**TIME SEQUENCE OF EVENTS FOR INCIDENTS THAT CAUSE A
DECREASE IN REACTOR COOLANT INVENTORY**

AP1000 LOCA CHRONOLOGY

Figure 15.6.3-1

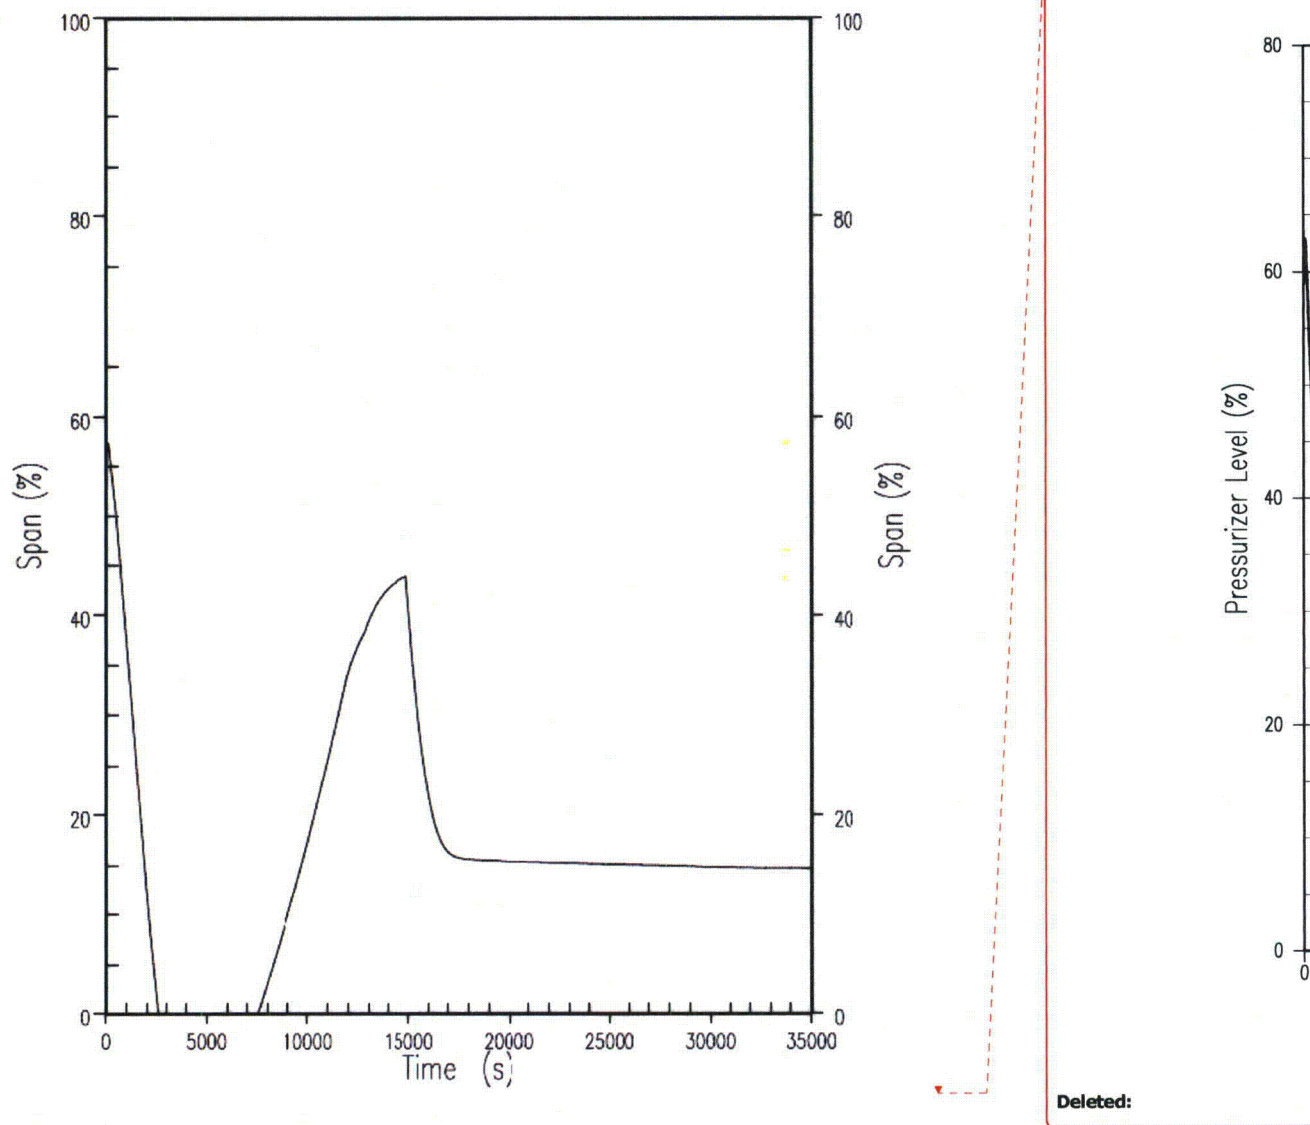
Comment [B71]: [15.6-69]
